FINAL ENVIRONMENTAL IMPACT REPORT

WEST COUNTY DETENTION FACILITY EXPANSION

STATE CLEARINGHOUSE #2015042003

July 2015

Figure 3.6-3
Existing Traffic Volumes

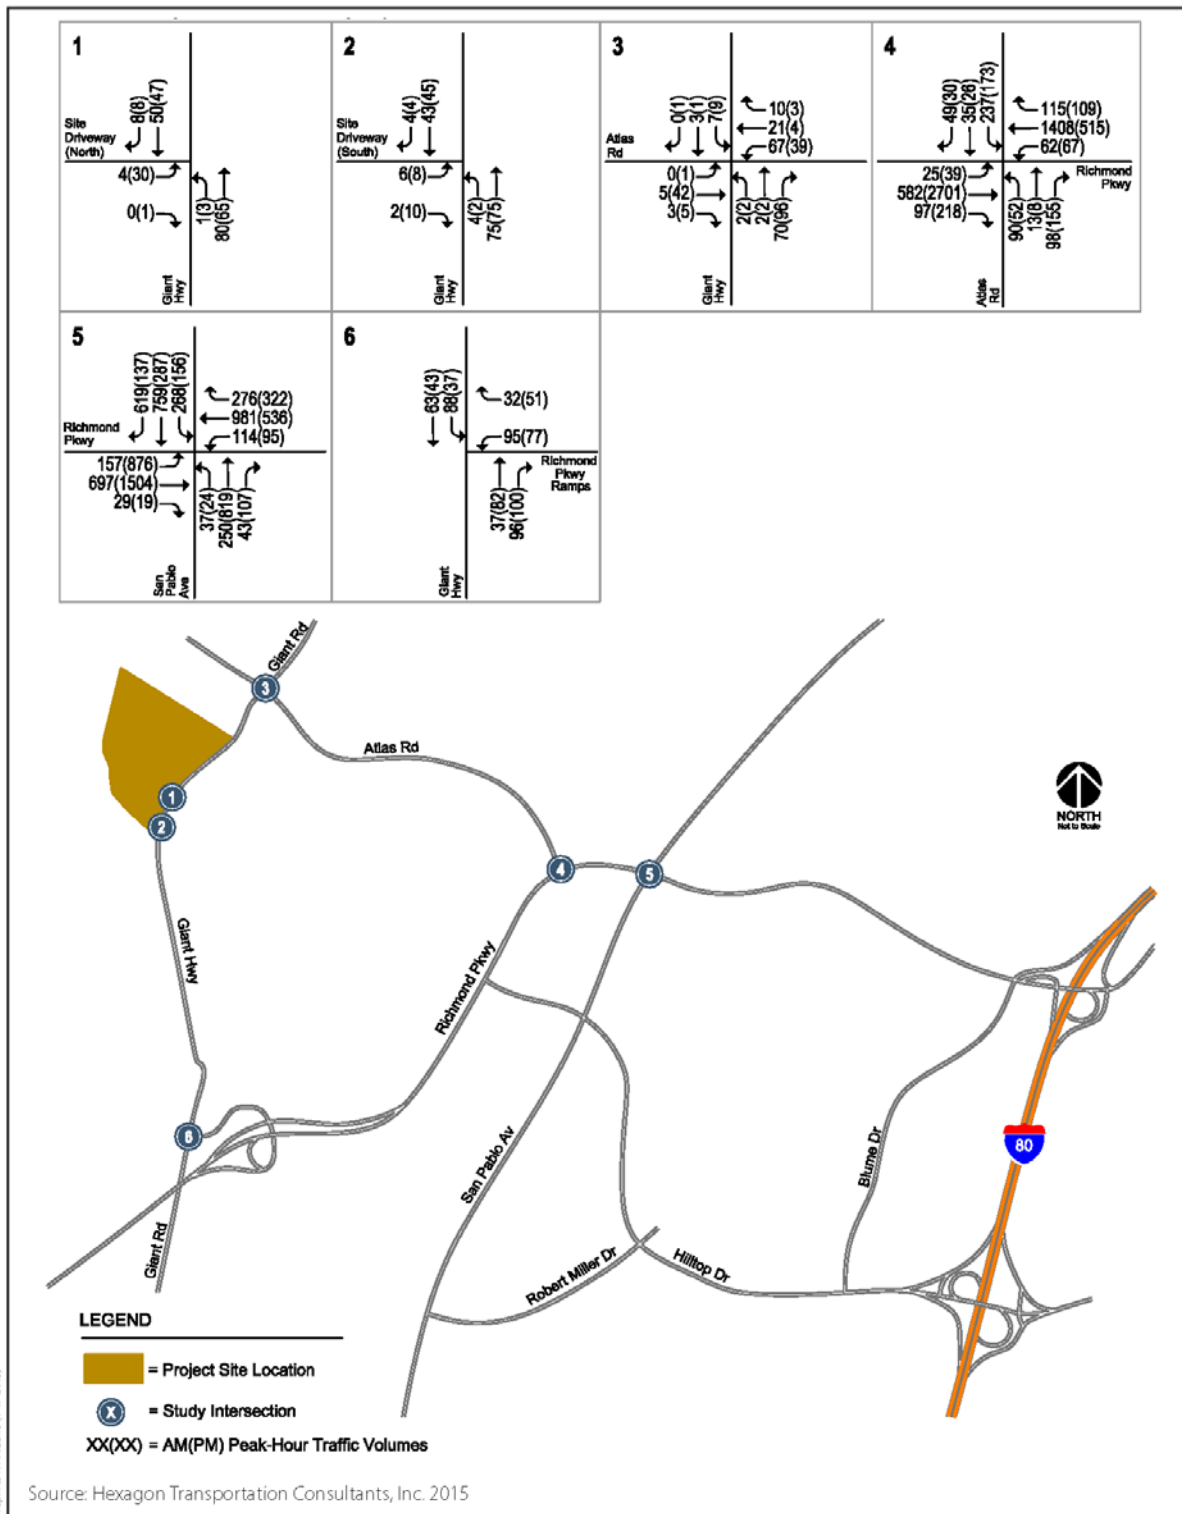
23) <u>Page 3.6-3, Section 3.6.2.4</u> : The discussion does not indicate how existing traffic volumes were determined or when the data was collected. It does not indicate whether traffic volumes shown on Figure 3.6-3 are daily volumes or (presumably) peak-hour volumes. (It is acknowledged that this information is provided later in Section 3.6.)	31

24) <u>Figure 3.6-3 [after Page 3.6-4]</u> : The figure does not indicate the time period(s) of the traffic count volumes. It is presumed that the two sets of numbers shown for each turning movement represent AM peak-hour and PM peak-hour volumes, respectively, but this should be indicated on the figure and/or explained in the text discussion.	32

Existing traffic volumes were determined based on field observations and data gathered for the project, as stated on page 3.6-4 of the Draft EIR. Field observations were made in February 2015, as shown on the traffic count data sheets in the technical appendices to Appendix B, *Transportation Study Results*, of the Draft EIR. The Final EIR text has been amended to clarify the date of collection of data already presented in Appendix B. The Final EIR also contains updated Figures 3.6-3 and 3.6-4 to include the full legends for those figures. The figures in Section 3.6 of the Draft EIR are reproductions of the figures in the traffic study in Appendix B of the Draft EIR, but one legend item was accidentally cropped out in production of the figures for the Draft EIR chapter. As described above, all of this information has already been made available to the public for review as part of the Draft EIR.

Please see response to Comment #31 in this letter. This information was presented in Appendix B, *Transportation Study Results*, of the Draft EIR.

Figures 3.6-3 and 3.6-4 have been replaced because a legend item was inadvertently cropped from the original figures in Appendix B and are presented on the following pages.

Figure 3.6-4
Project Trip Distribution and Assignment

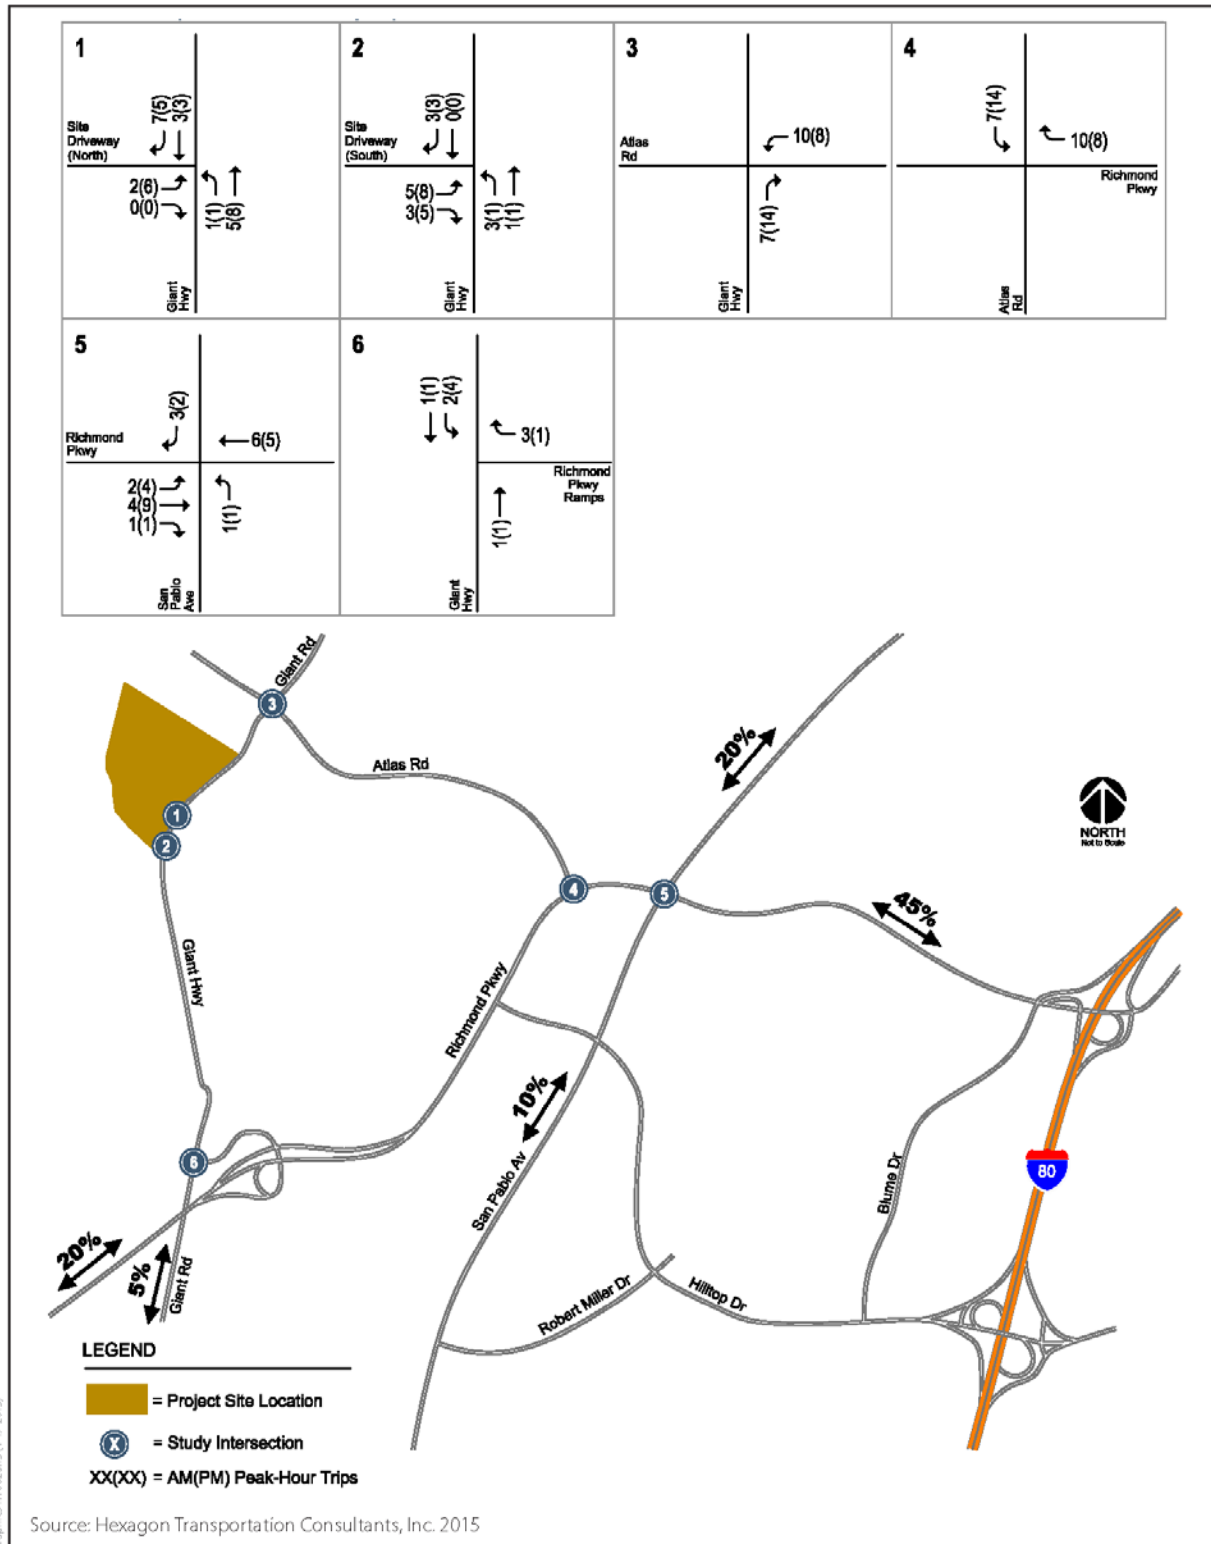
26) <u>Figure 3.6-4 [after Page 3.6-10]</u> : The same comment regarding Figure 3.6-3 (Comment #24) also applies to Figure 3.6-4.	34
Alternatives	
27) <u>Page 4-3, Section 4.2.3</u> : There is no explanation for why this alternative was selected for evaluation. It does not appear to reduce or avoid a significant impact identified for the proposed project. It therefore fails to comply with the requirements of <i>CEQA Guidelines</i> Section 15126.6.	35

Please see response to Comment #31 in this letter. This information was presented in Appendix B, *Transportation Study Results*, of the Draft EIR.
